Project: PRA-ROCR 10(5)
The purpose of this Amendment is to:

Amendment No. 0002
Project PRA-ROCR 10(5)
Rock Creek Park
Solicitation: DTFH71-16-R-00001

Project Name: Beach Drive from Rock Creek Parkway to Maryland State Line

AMENDMENT NO. 2 ◇1	PMIS NO.	NPS NO.	STATE	PROJECT	SHEET NO.
	044965	821 / 100425	DC	PRA-ROCR 10(5)	D40

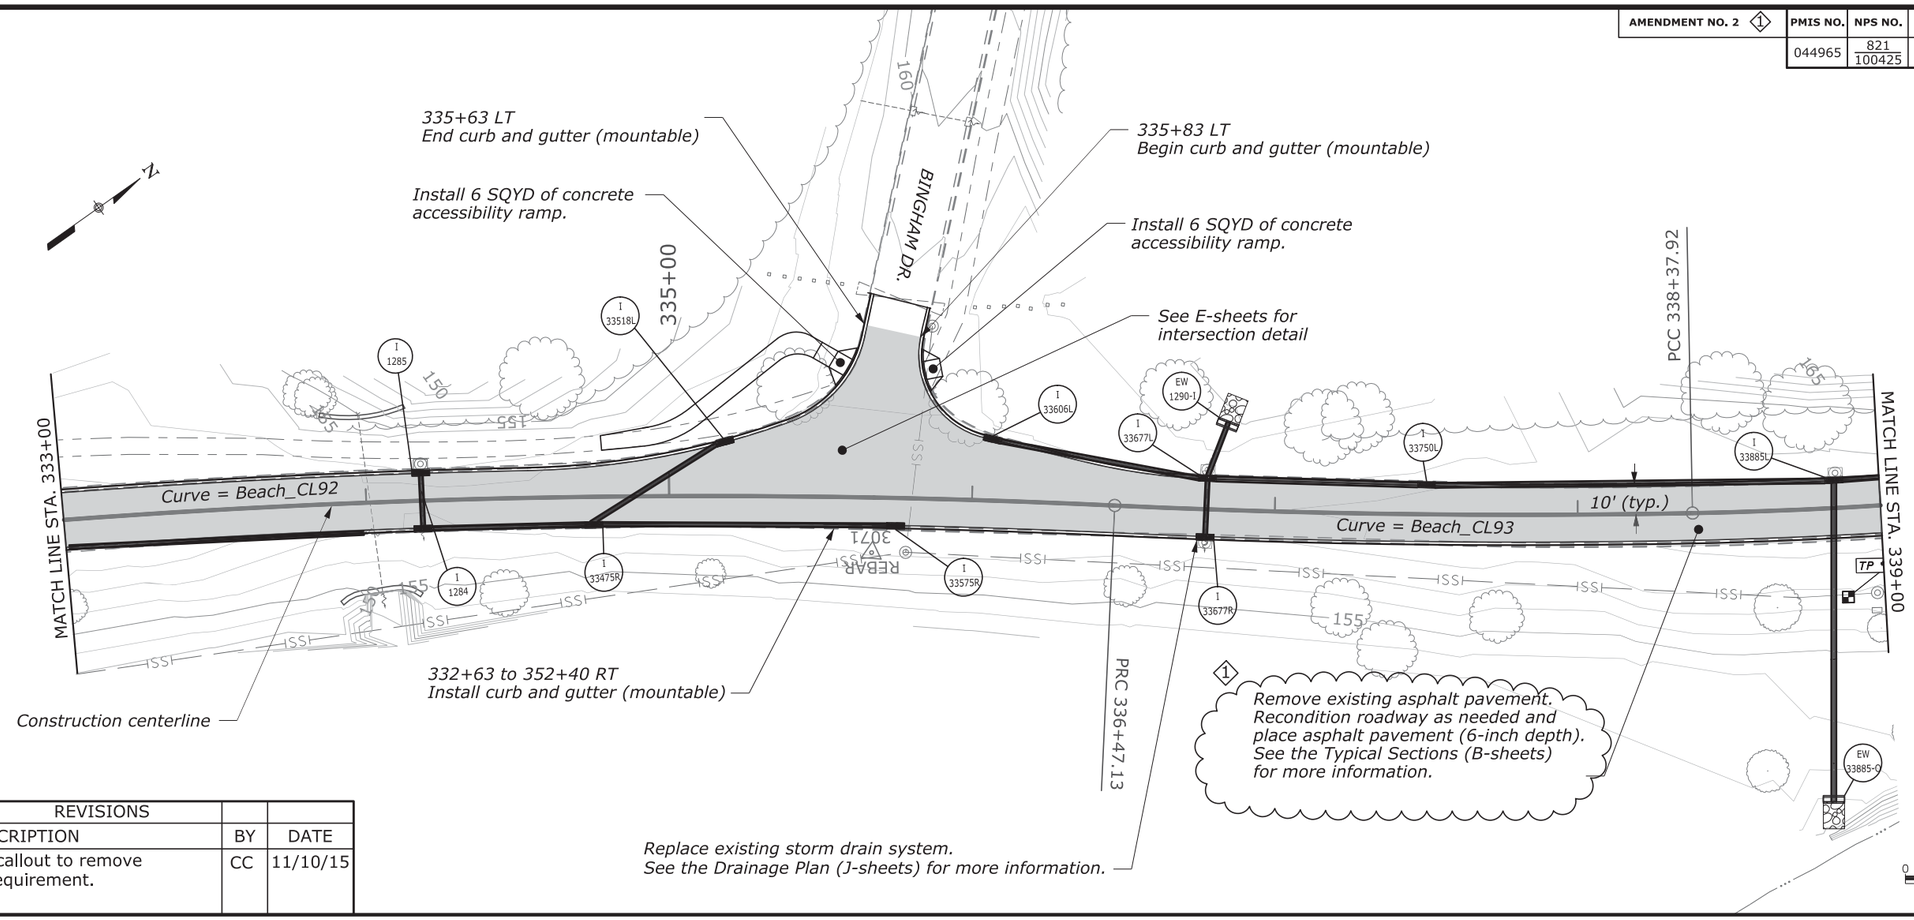
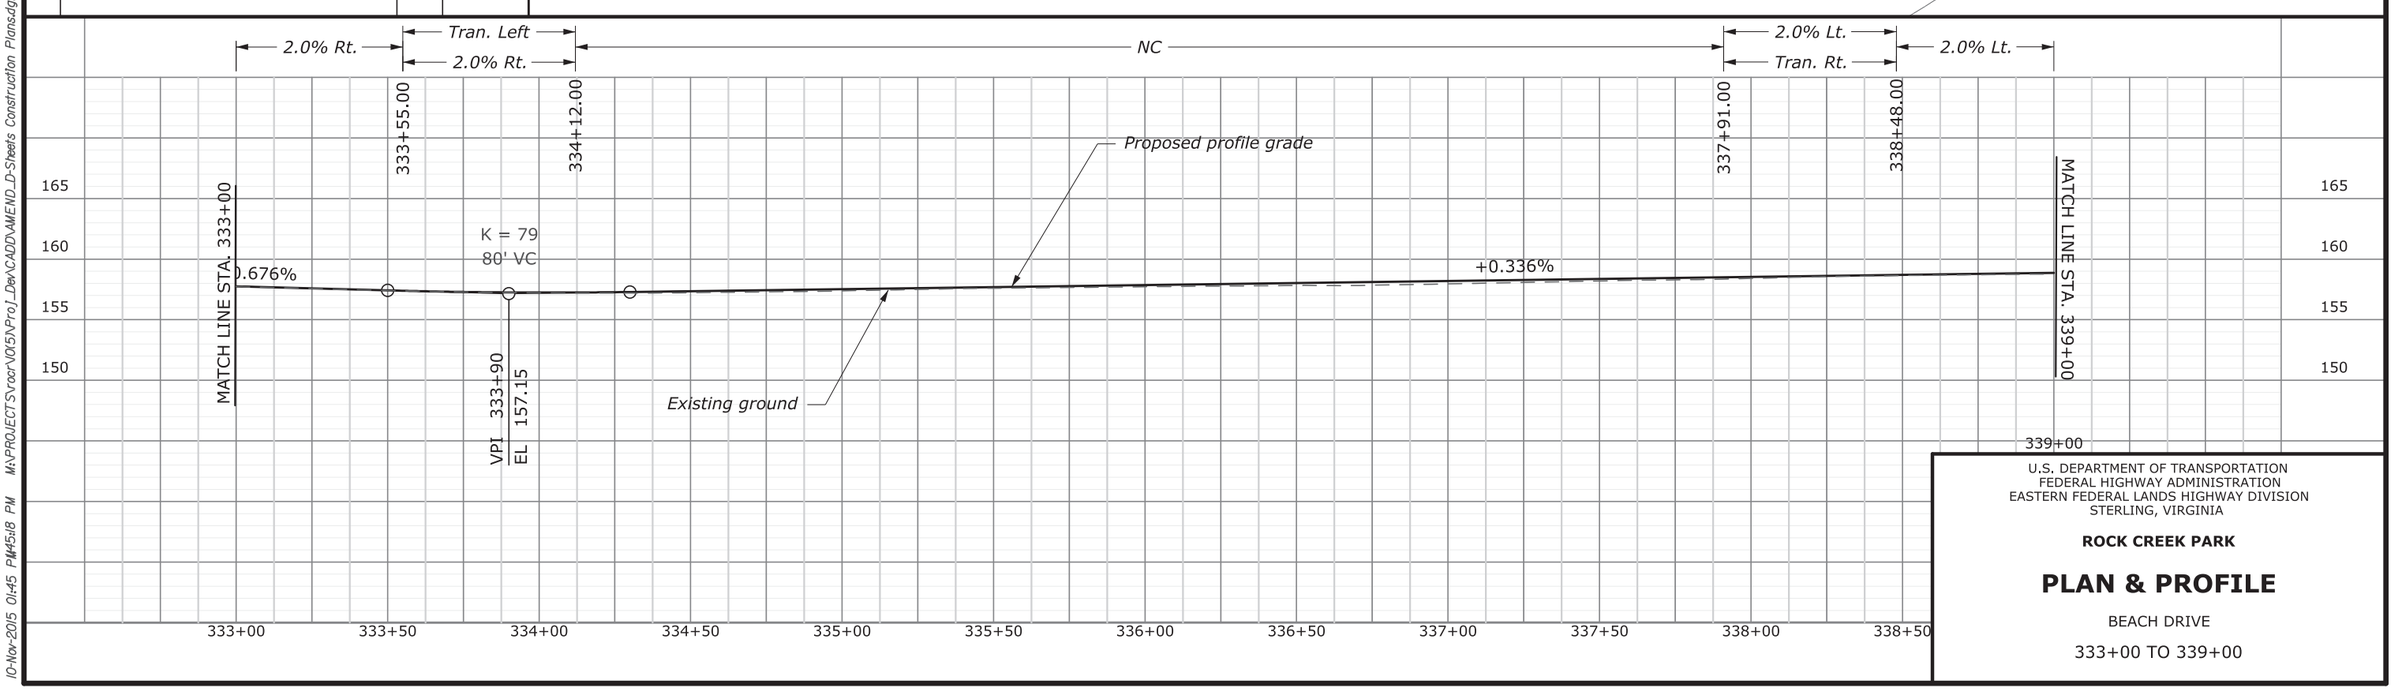
REVISIONS			
NO.	DESCRIPTION	BY	DATE
◇1	Revised the callout to remove the milling requirement.	CC	11/10/15

AMENDMENT NO. 2 ①	PMIS NO.	NPS NO.	STATE	PROJECT	SHEET NO.
	044965	821 / 100425	DC	PRA-ROCR 10(5)	D41

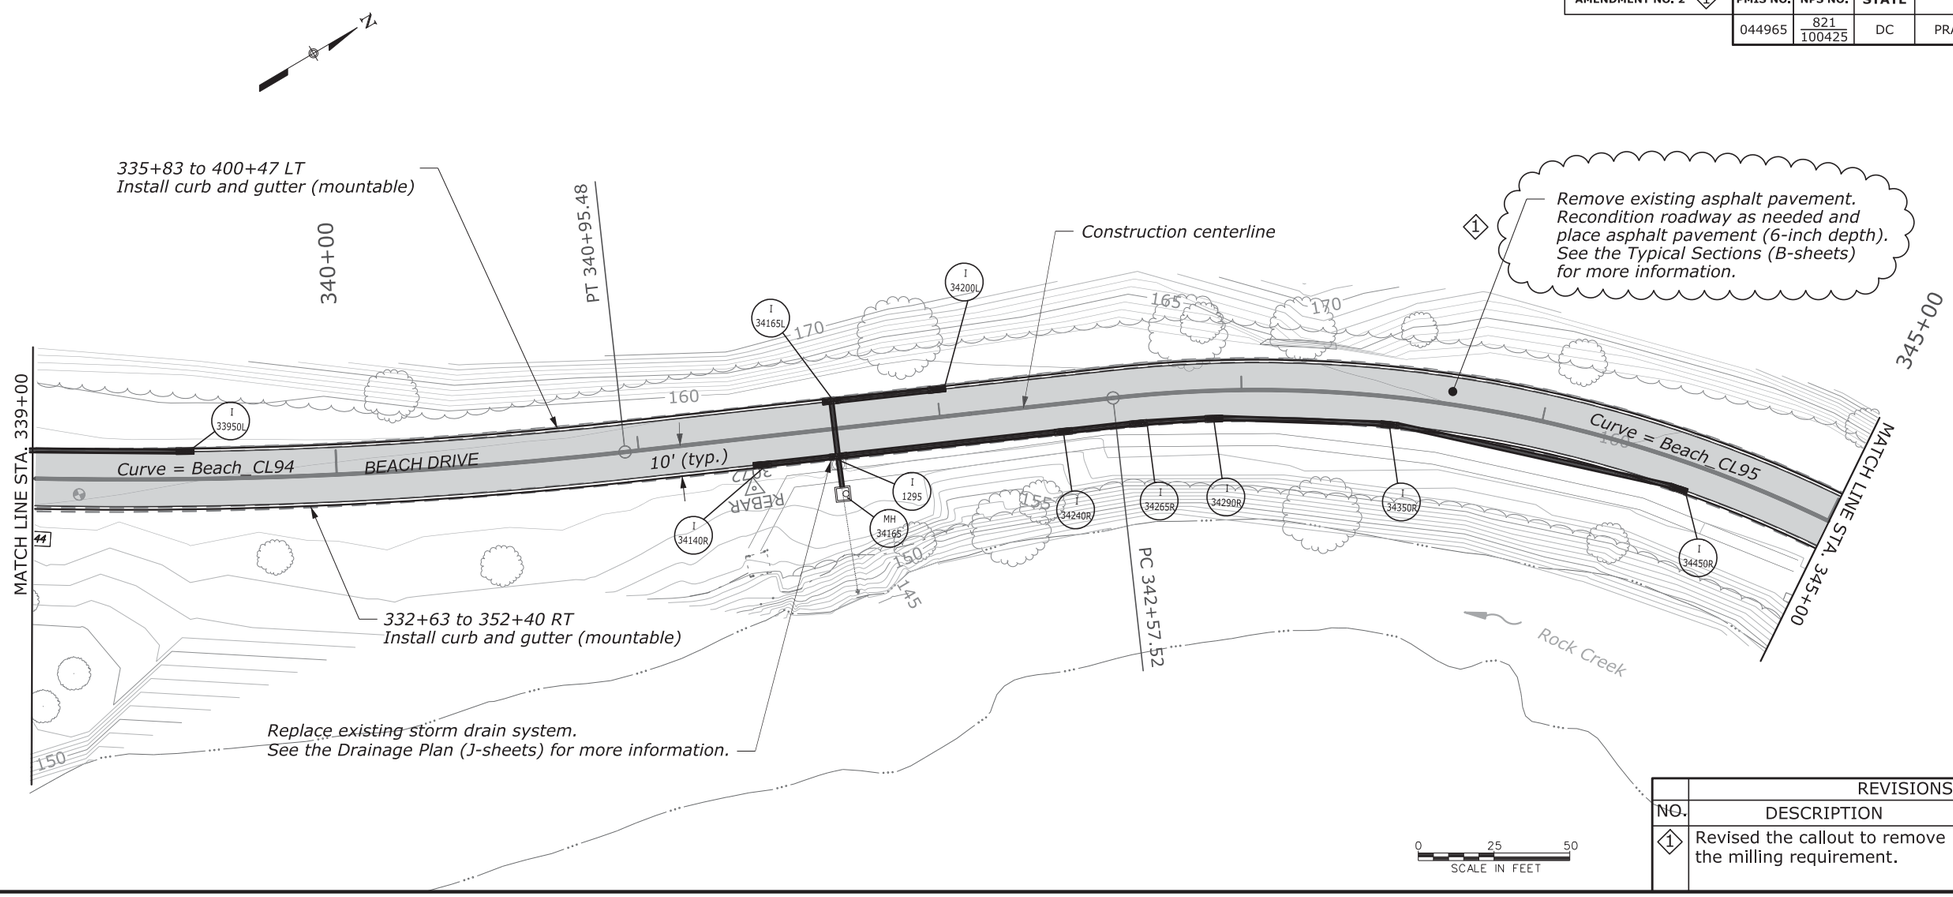
REVISIONS			
NO.	DESCRIPTION	BY	DATE
①	Revised the callout to remove the milling requirement.	CC	11/10/15

AMENDMENT NO. 2 ◇1	PMIS NO.	NPS NO.	STATE	PROJECT	SHEET NO.
	044965	821 / 100425	DC	PRA-ROCR 10(5)	D42

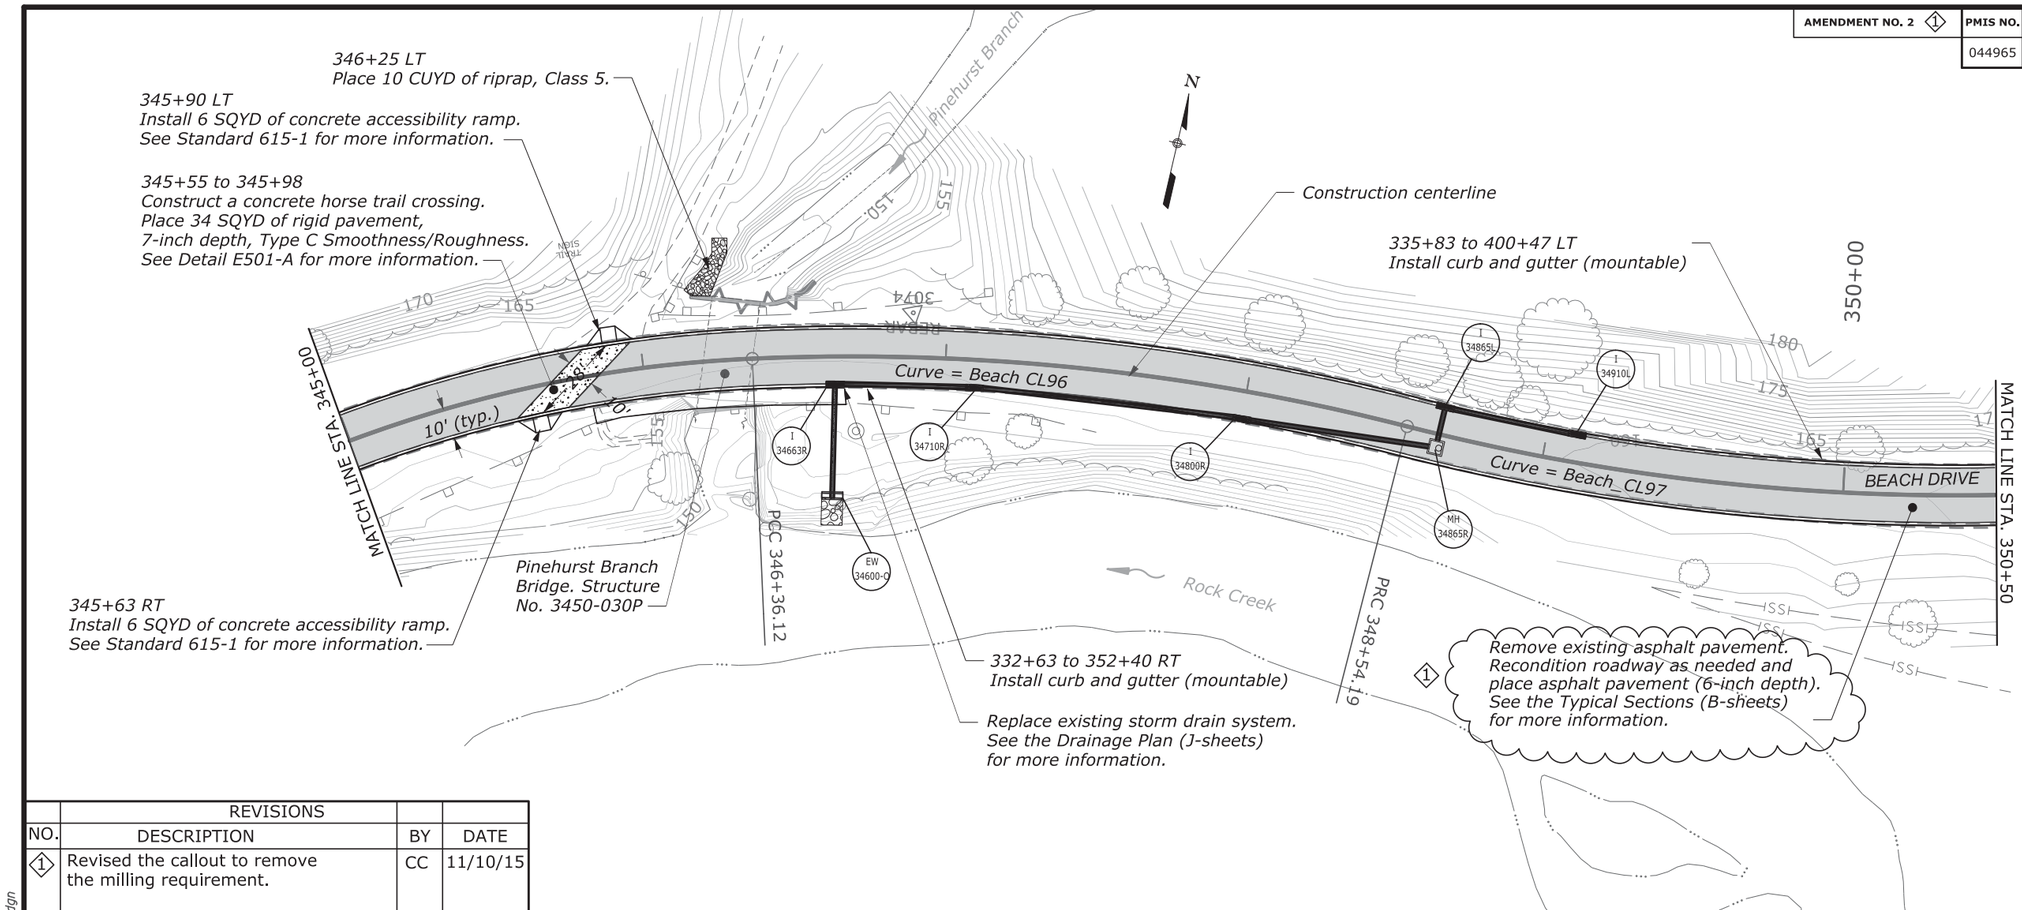
REVISIONS			
NO.	DESCRIPTION	BY	DATE
◇1	Revised the callout to remove the milling requirement.	CC	11/10/15

AMENDMENT NO. 2 ◇1	PMIS NO.	NPS NO.	STATE	PROJECT	SHEET NO.
	044965	821 / 100425	DC	PRA-ROCR 10(5)	D43

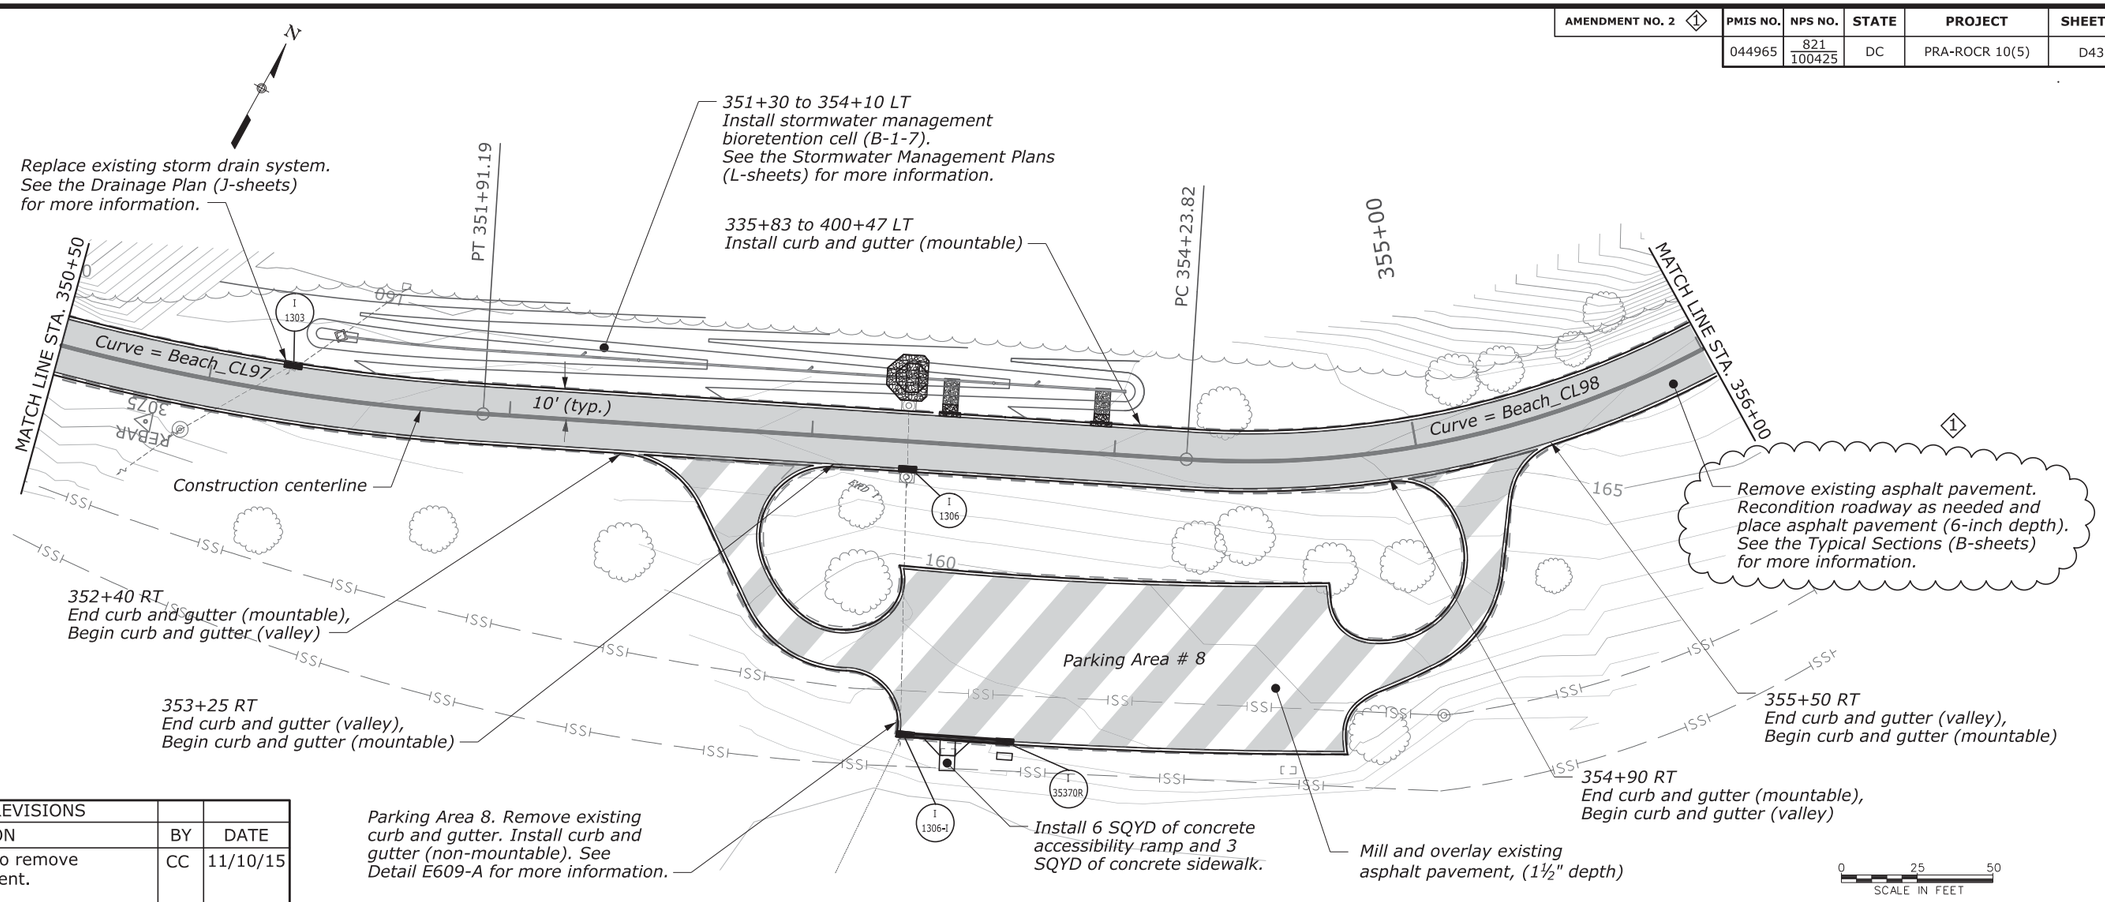
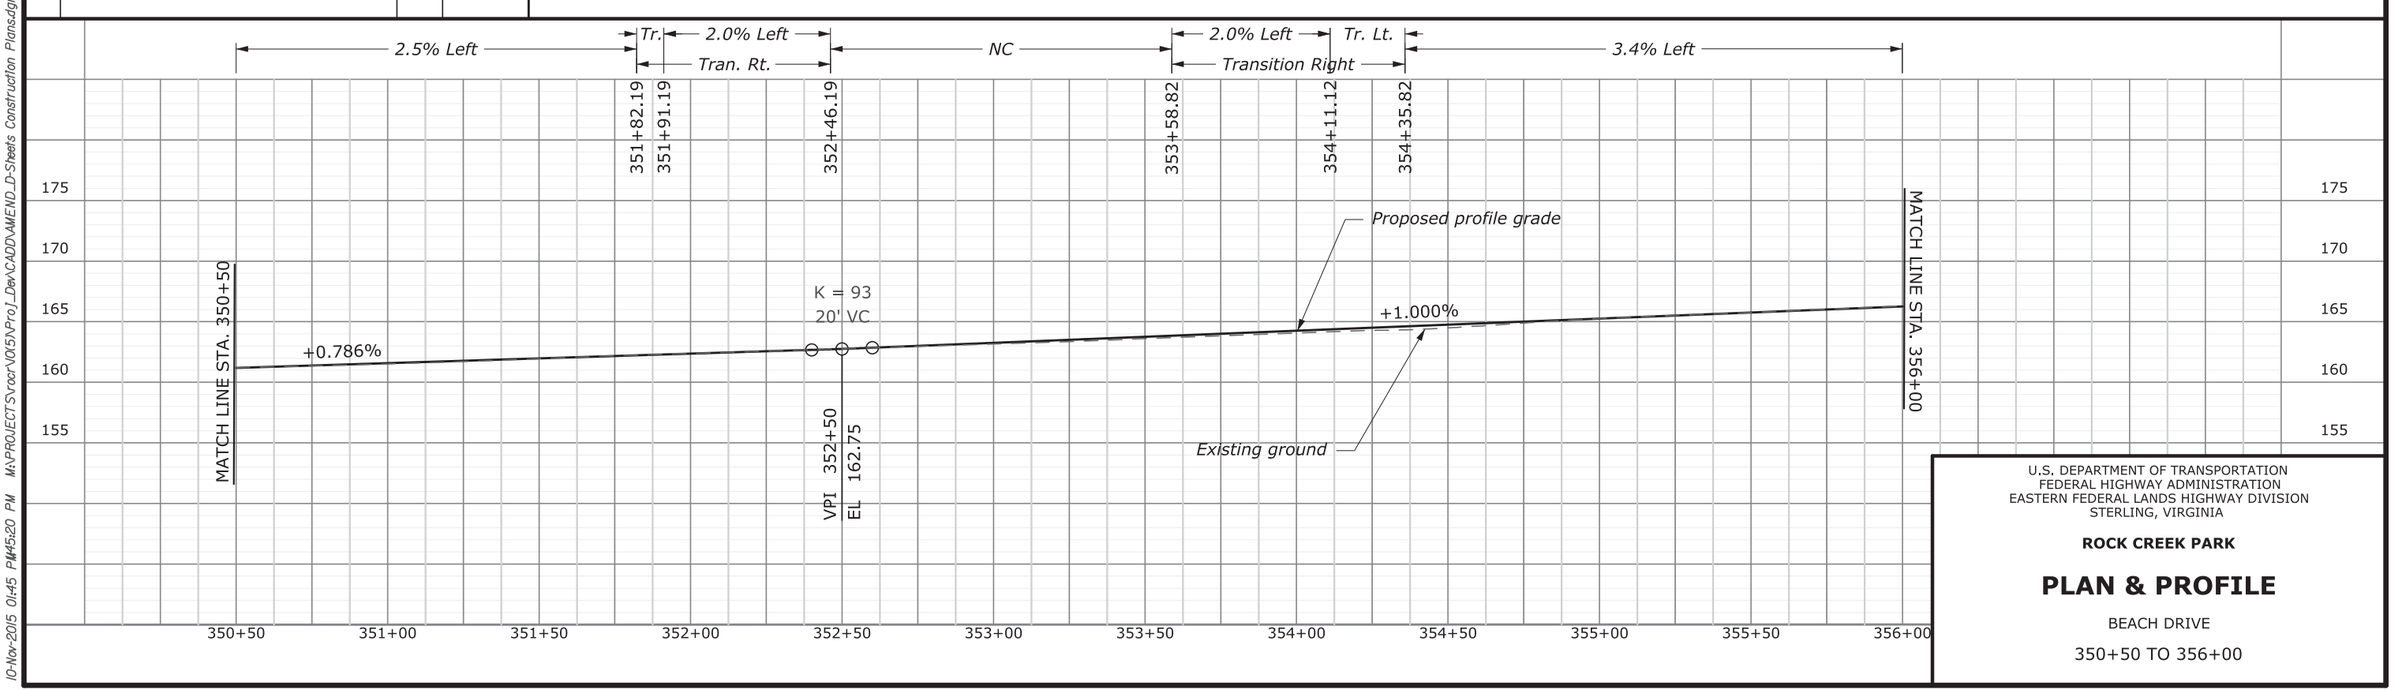
REVISIONS			
NO.	DESCRIPTION	BY	DATE
◇1	Revised the callout to remove the milling requirement.	CC	11/10/15
